Access Compliance Report Public Rights-of-Way (Pedestrian Signals)

Main Street: FAIRHAVEN_AVE Cross Street: ESPLANADE_AVE Location: SE

ADA ID: SGRK211007111217 Signal Type: One Push Button-Non APS Overall Compliance: No Severity Scores: BTN 1: 35 BTN 2: N/A No BTN: N/A

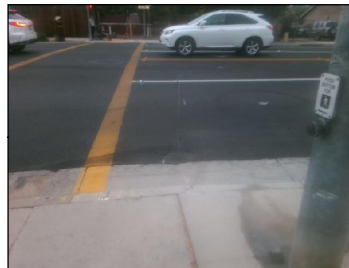
OC Std/PROW: MUTCD 4e.08, R404.2, R404.3

Possible Solutions: Replace Signal Push Button With APS Button. Remove & Relocate Sign.
